PRELIMINARY SITE GRADING CONSTRUCTION PLANS
FOR
HILLSIDE AT LORSON RANCH
EARLY OVERLOT GRADING / EROSION CONTROL PLANS

PROJECT:
HILLSIDE AT LORSON RANCH
LORSON BLVD AND WALLEYE DR
COLORADO SPRINGS, COLORADO

**COVER SHEET
EARLY GRADING AND
EROSION CONTROL PLAN**

**POND E1
POND FOREBAY DETAILS**

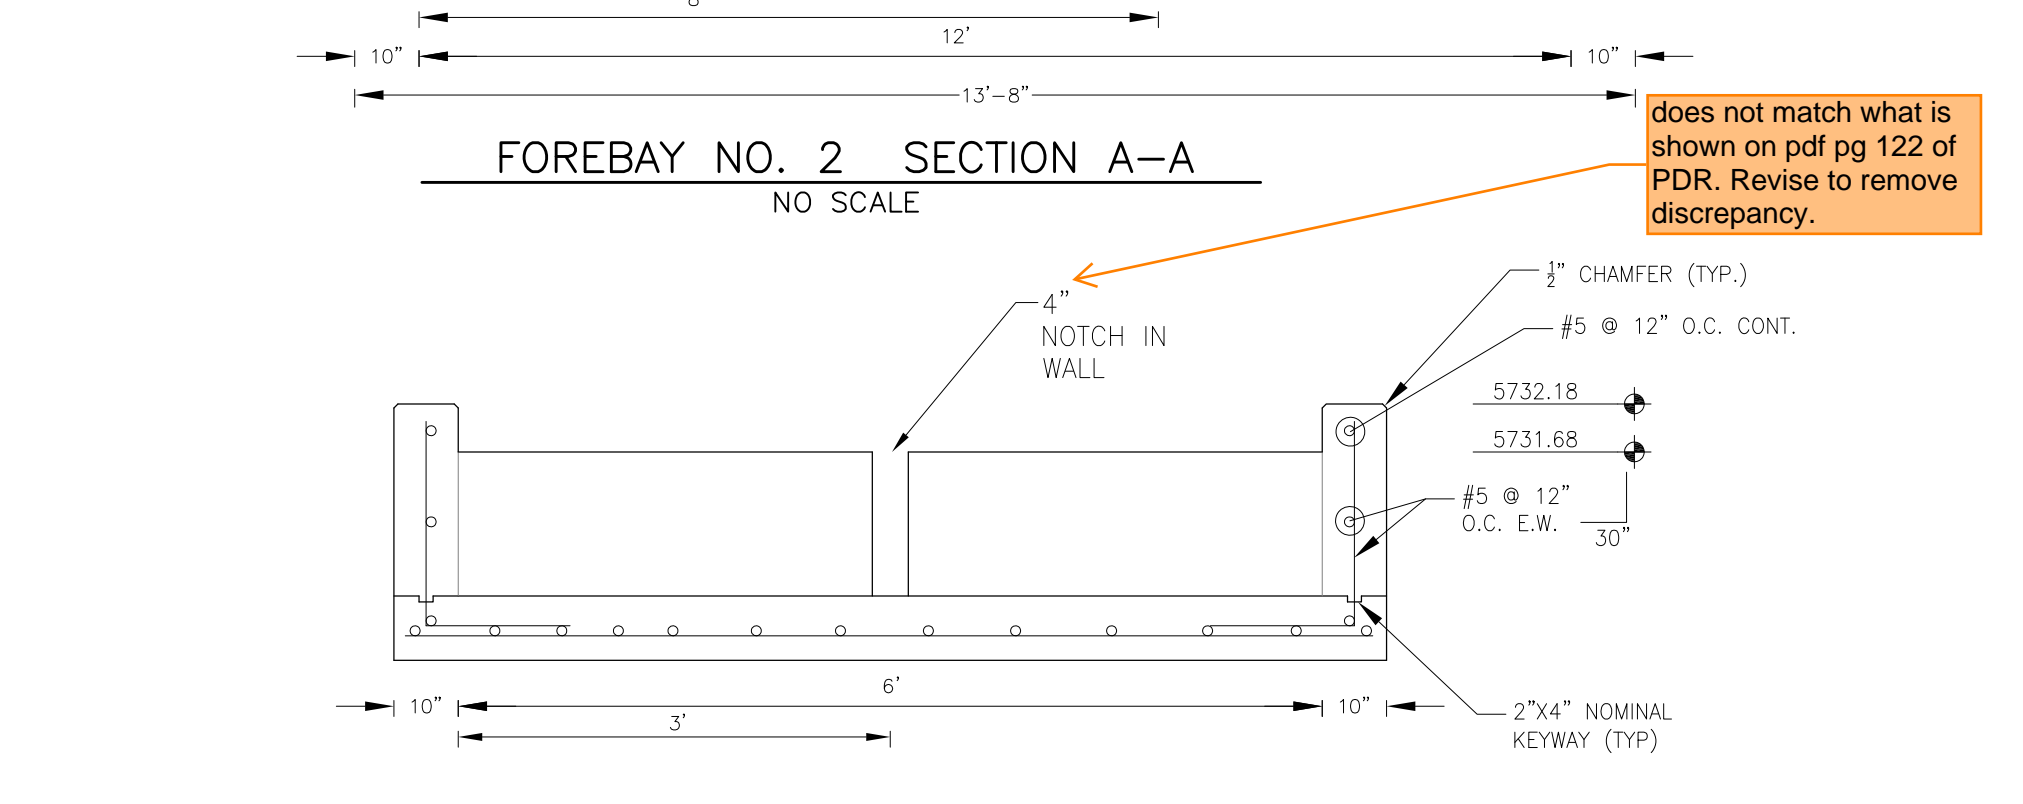
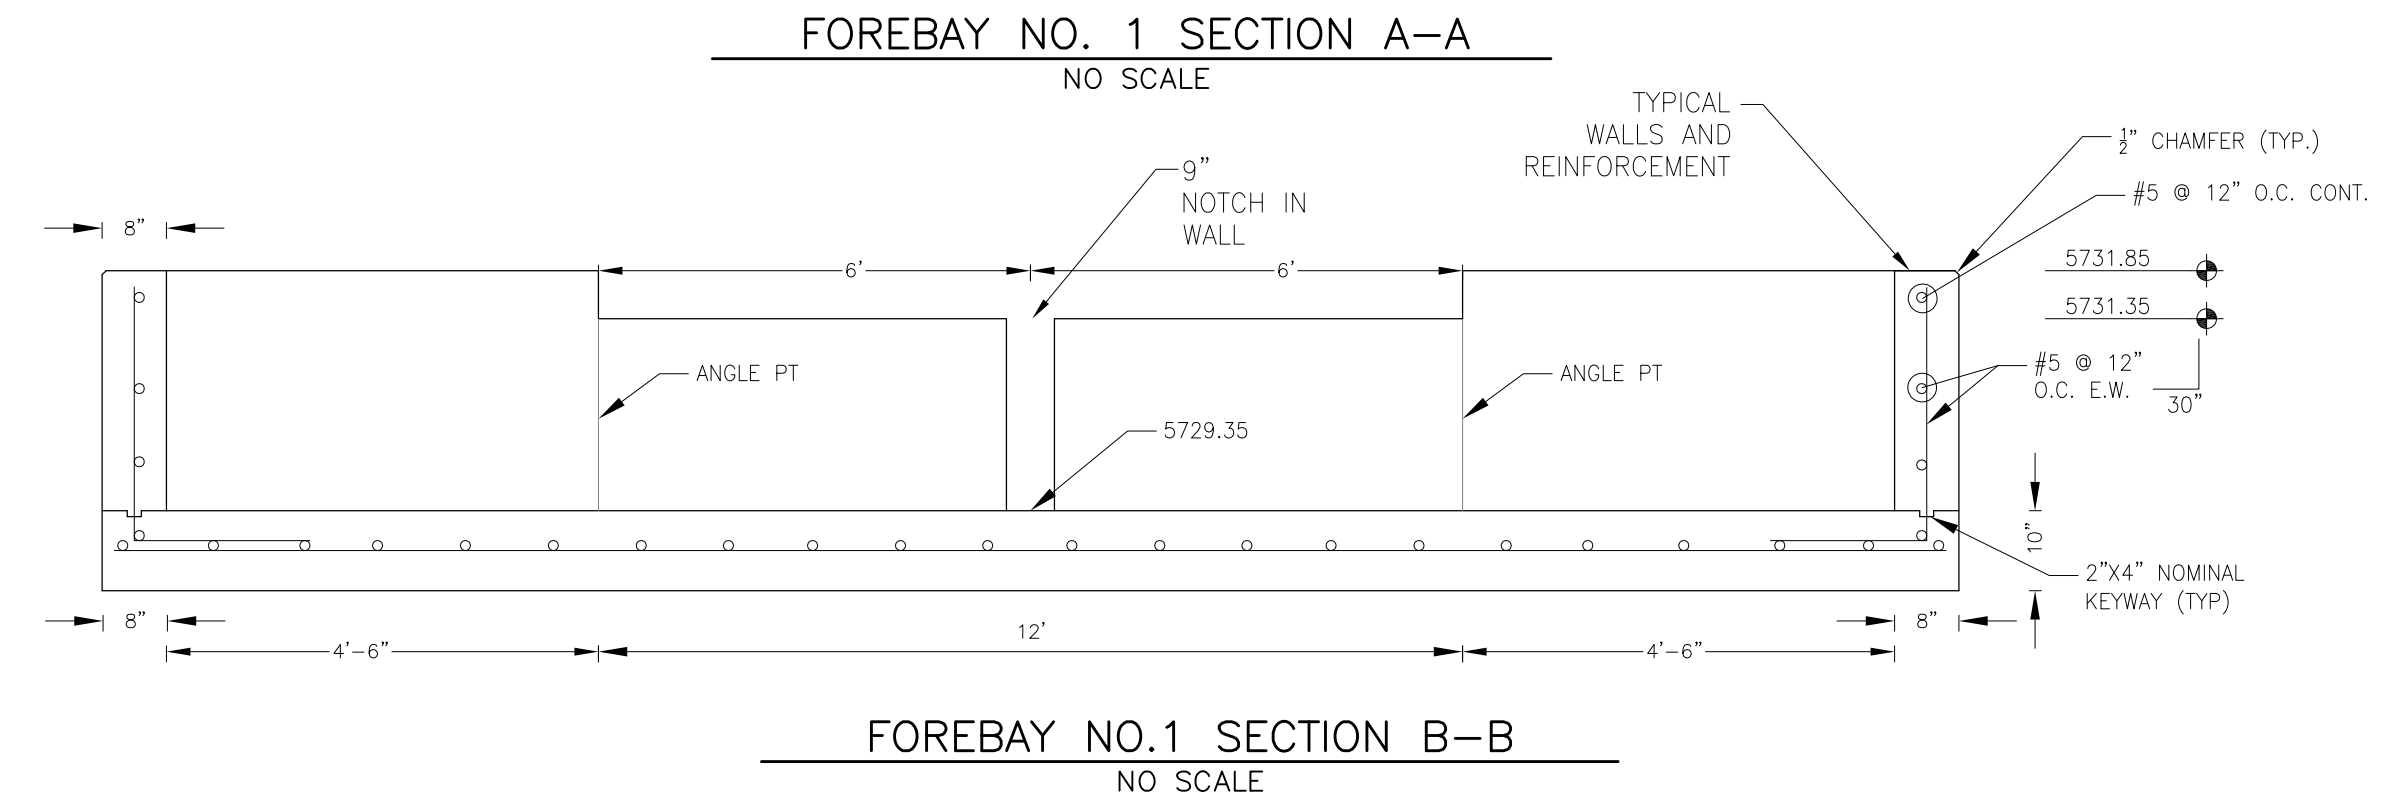
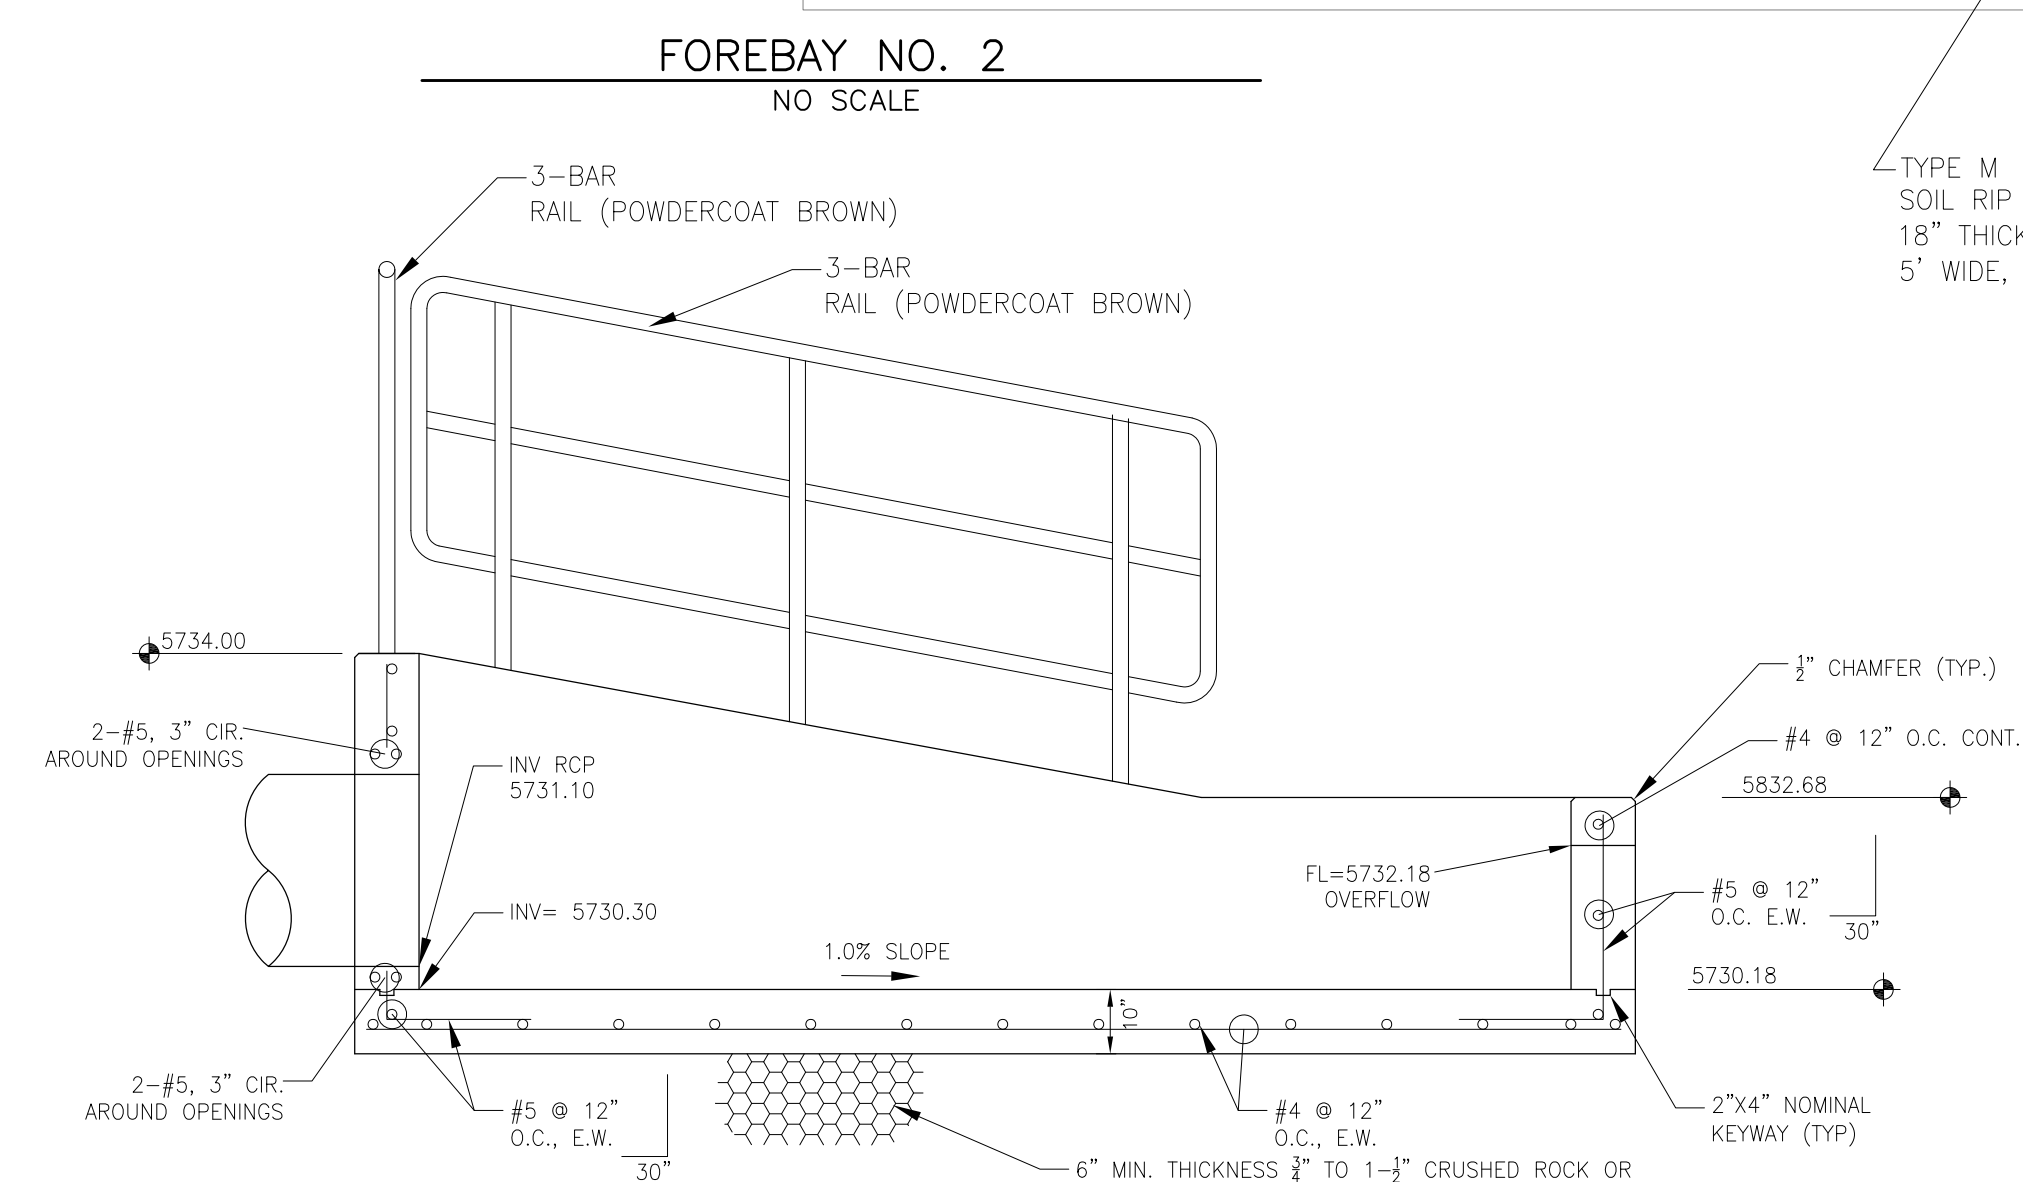
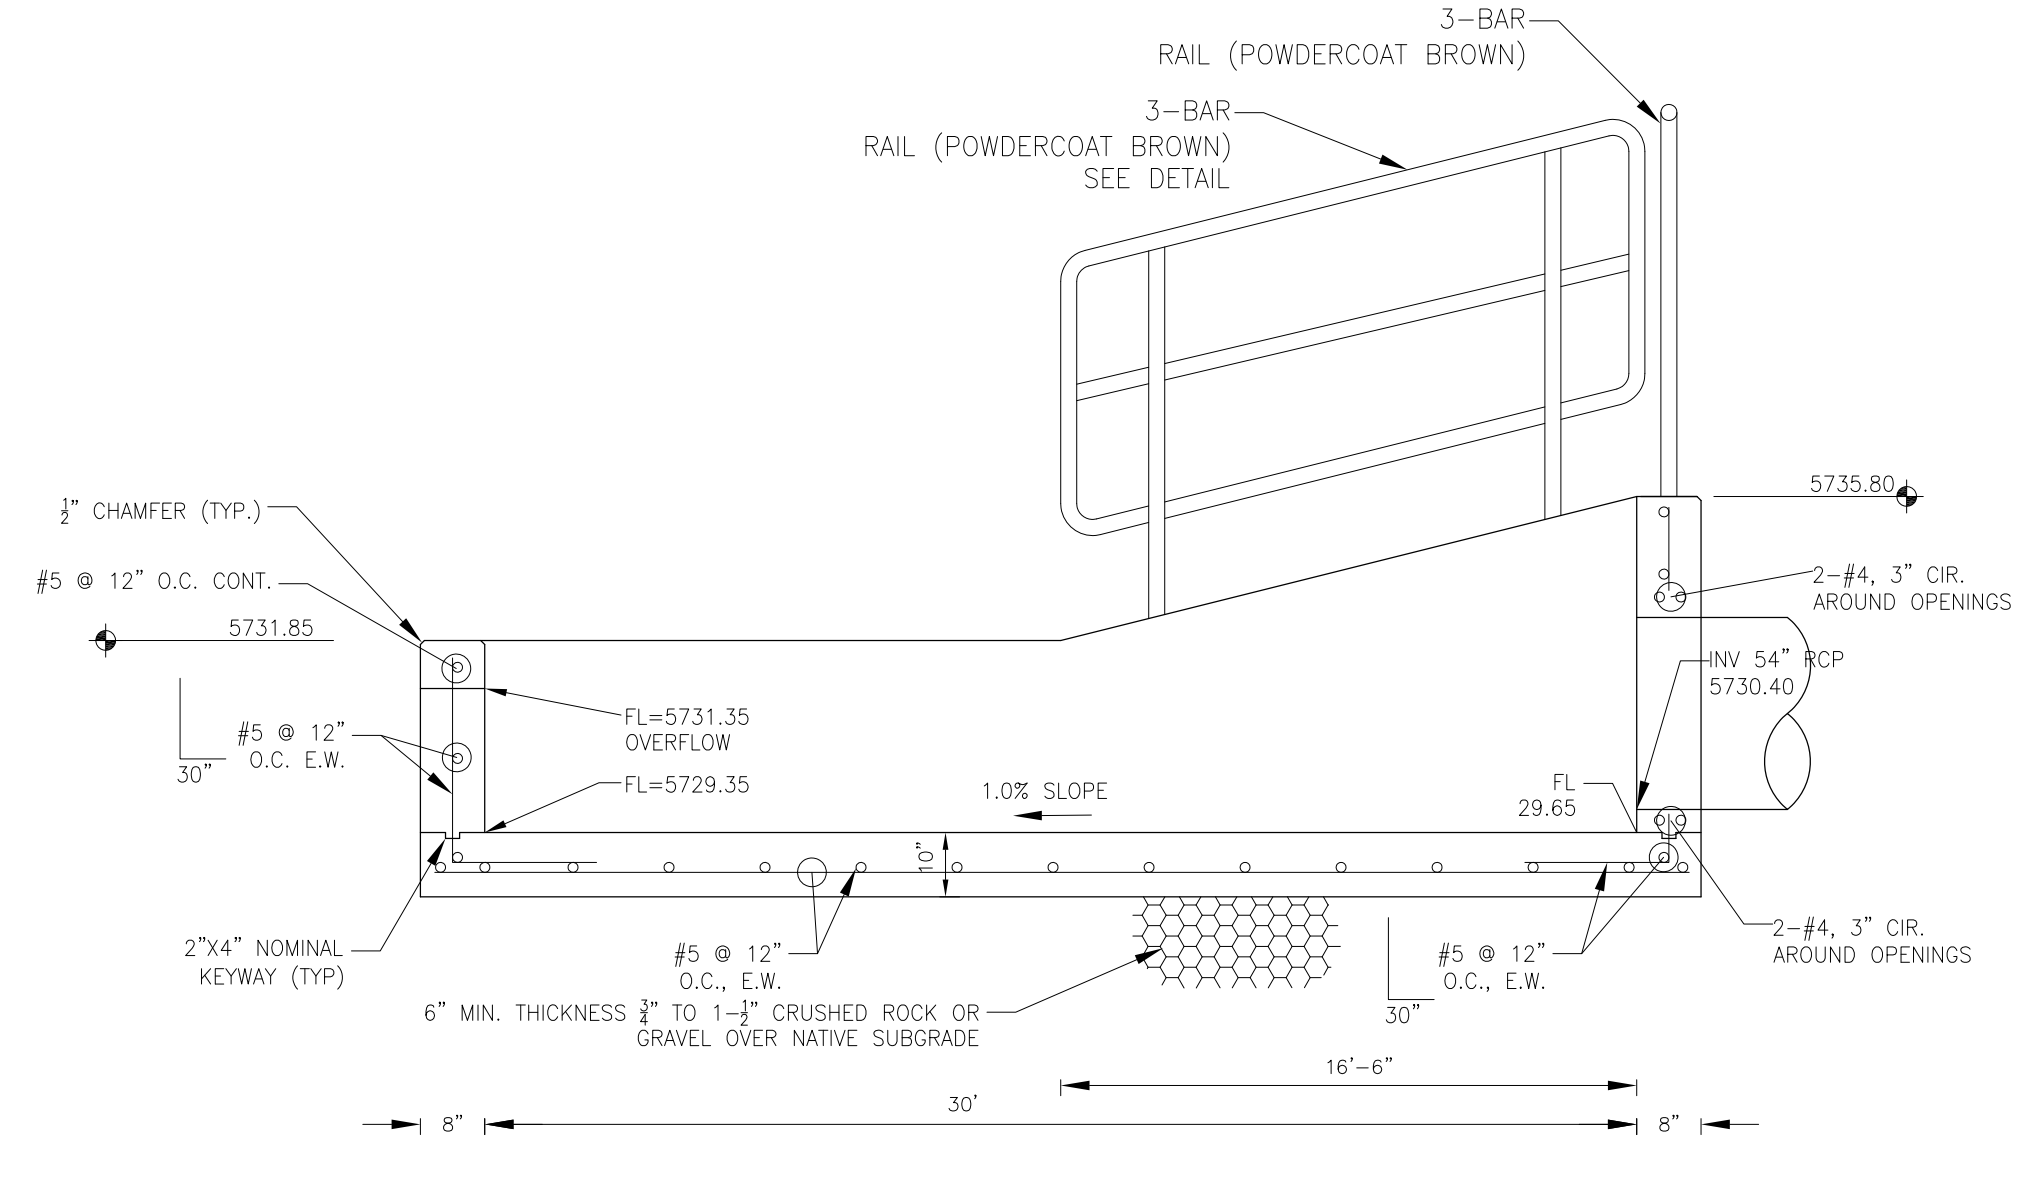
does not match what is shown on pdf pg 122 of PDR. Revise to remove discrepancy.
